## Road safety audit finding

Above: The kerb ramp on the south-eastern corner of the intersection.

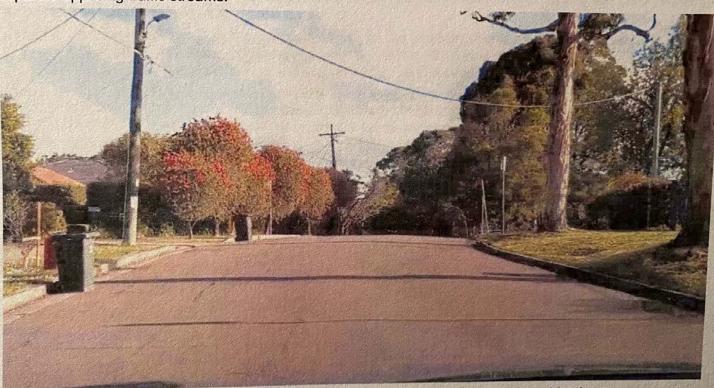
The kerb ramps at both of these corners of the intersection are poorly aligned and direct pedestrians too Road. This is especially the case for vision impaired pedestrians who rely on the alignment of the ramp direction. Mobility-impaired pedestrians may also be affected, especially if using a wheeled device, since tendency to roll down or up the ramp in a perpendicular trajectory to the ramp.
